## Fuel Primer Bulb Assembly

### Models Affected

Models Covered	Serial Number
Mercury/Mariner/Force All versions except Verado	All
75-115 EFI	1B366823 and below

**Old primer bulb**  
a - 13330Q06 or 13330K06

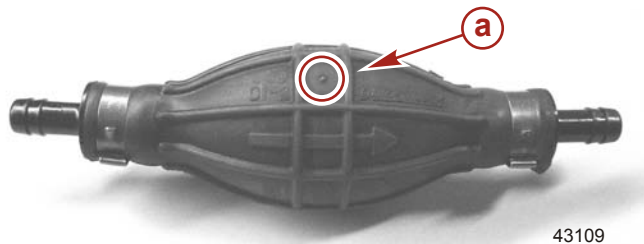
Mercury Marine has released a new fuel primer bulb assembly which is more resistant to fuels containing alcohol and to kinking associated with some rigging applications. If you receive any customer complaints from using the 13330K06 or 13330Q06 primer bulb, replace with the new bulb.

- P/N 13330K07 supersedes 13330K06
- P/N 13330Q07 supersedes 13330Q06

The new primer bulb can be identified by the small dot just above the flow directional arrow as shown in the following picture.

**New primer bulb**  
a - 13330Q07 or 13330K07
